PLAN COMMISSION MEETING AGENDA Thursday, November 21, 2024 at 6:00 P.M.

REPORT TO THE PLAN COMMISSION

Preliminary Plat

Date:	October 31, 2024
To:	William Gentil. Stepping Stone Homes
From:	Régulo Martínez-Montilva, Planning Manager City of Franklin, Department of City Development
RE:	Review comments for preliminary plat application regarding the proposed Woodfield Trail Subdivision. 9524 S Sophia Ct

Unified Development Ordinance (UDO) Table 15-3.0209A, R-8 Multiple- Family Residence District Development Standards.

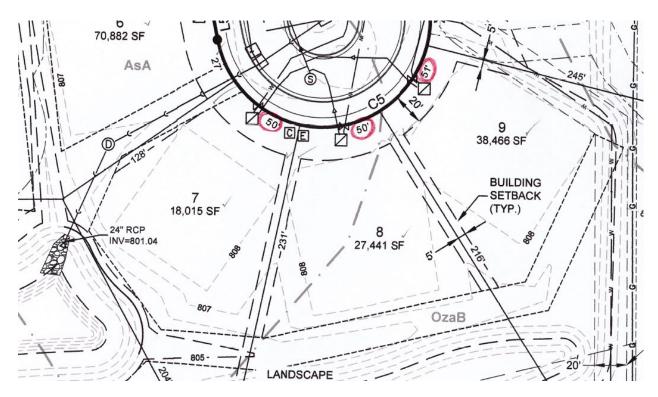
1. **Minimum lot width.** Lots 7, 8 and 9 don't meet the minimum lot width of 60 feet. Pursuant to the Unified Development Ordinance (UDO), subdivisions must be "designed as to provide each lot with a minimum of 60 feet frontage along a public street". Please revise lots 7,8 and 9.

If you consider that meeting the minimum width for these lots would result in severe hardship, you may apply for a Land Division Variance, subject to approval by the Plan Commission. Application form and relevant UDO section attached.

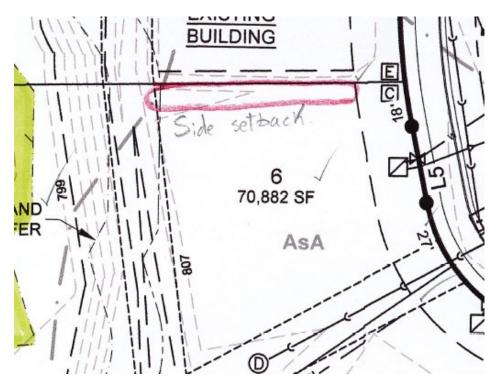
2. Side yard setback. Please revise lot 6 to depict the minimum 5-foot setback.

This was updated by Pinnacle Engineering Group.

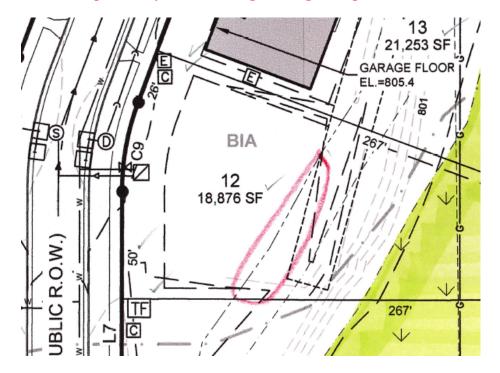
3. Wetland setback. Please revise lot 12 to depict the building footprint outside the required 50-foot wetland setback.

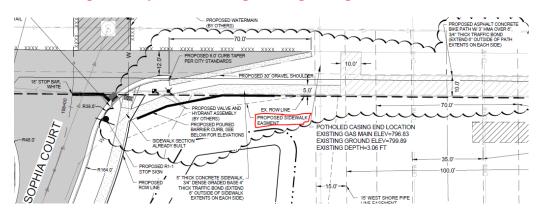
5. Use statement. Staff acknowledges that this plat is for a single-family subdivision, but pursuant to UDO Section 15-7.0501H, please add a use statement with the underlined information:
"Use Statement. A statement of the proposed use of the lots stating the use type of buildings and/or uses proposed to occupy the lots, number of proposed lots, and number of dwelling units per lot, and proposed density".

A revised project narrative has been provided to include this information.

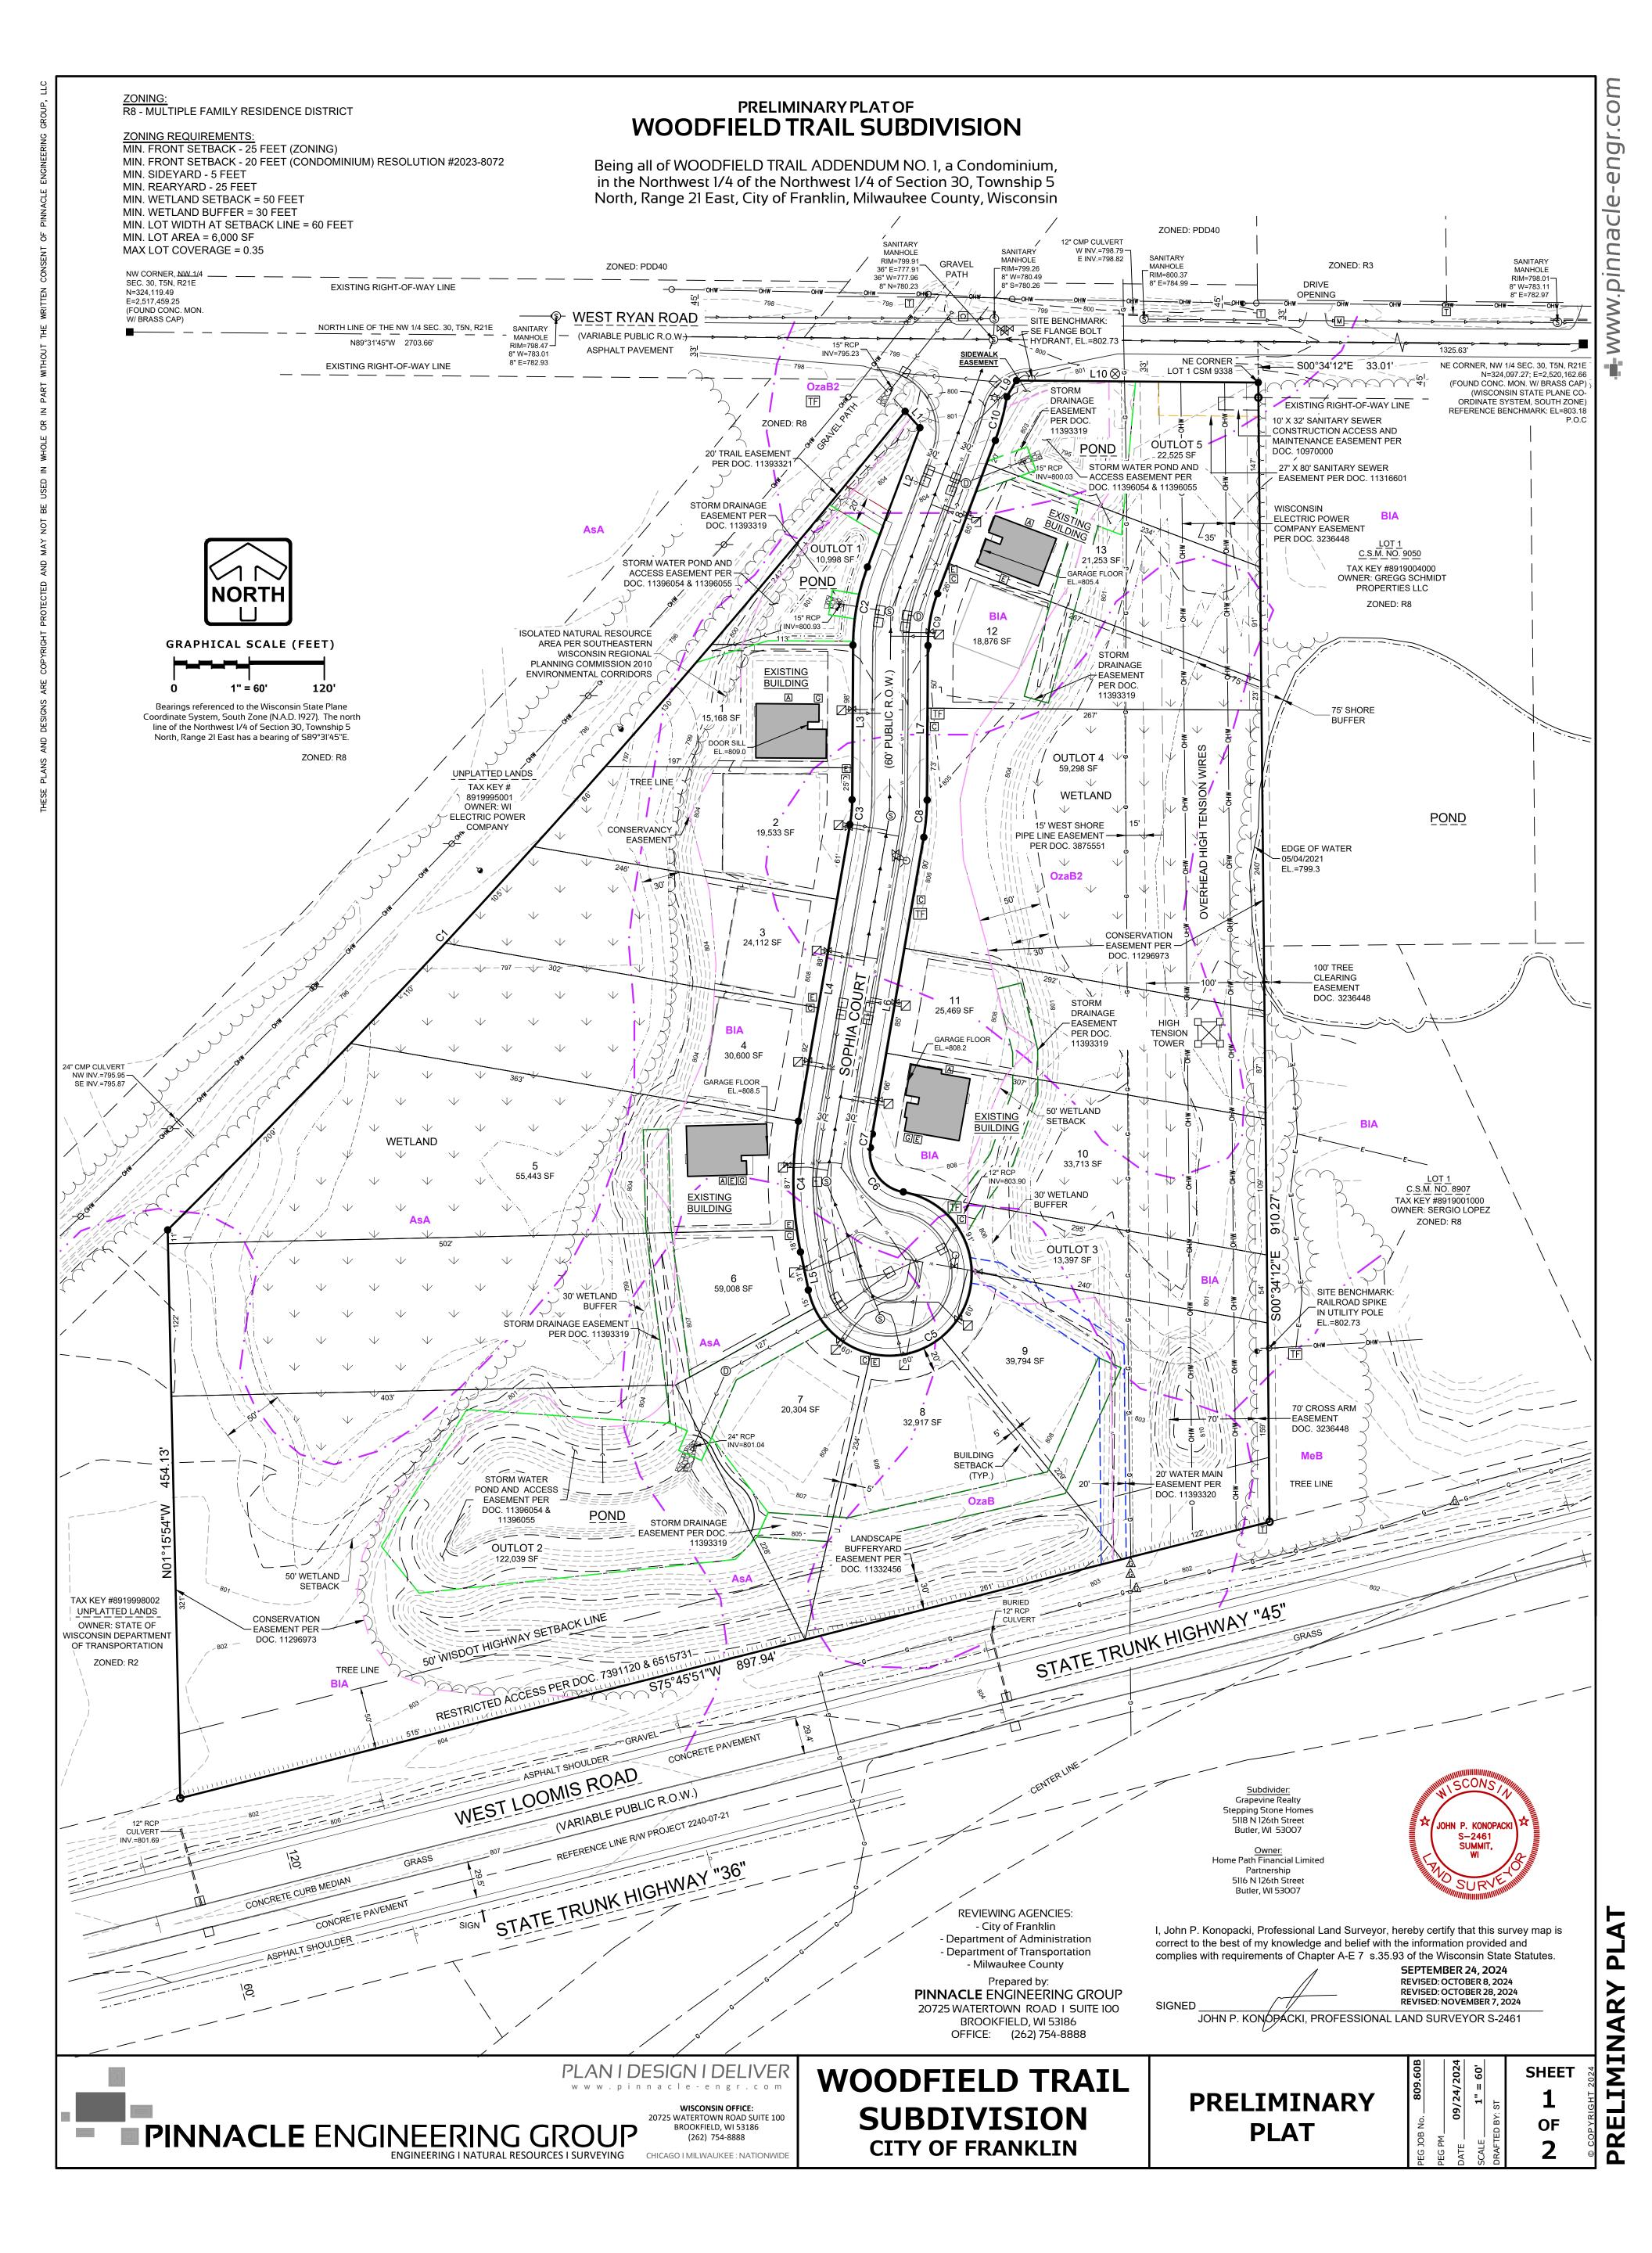
18. Replace note #10 with "Wetlands delineation per the recorded Certified Survey Map No. 9338

This was updated by Pinnacle Engineering Group.
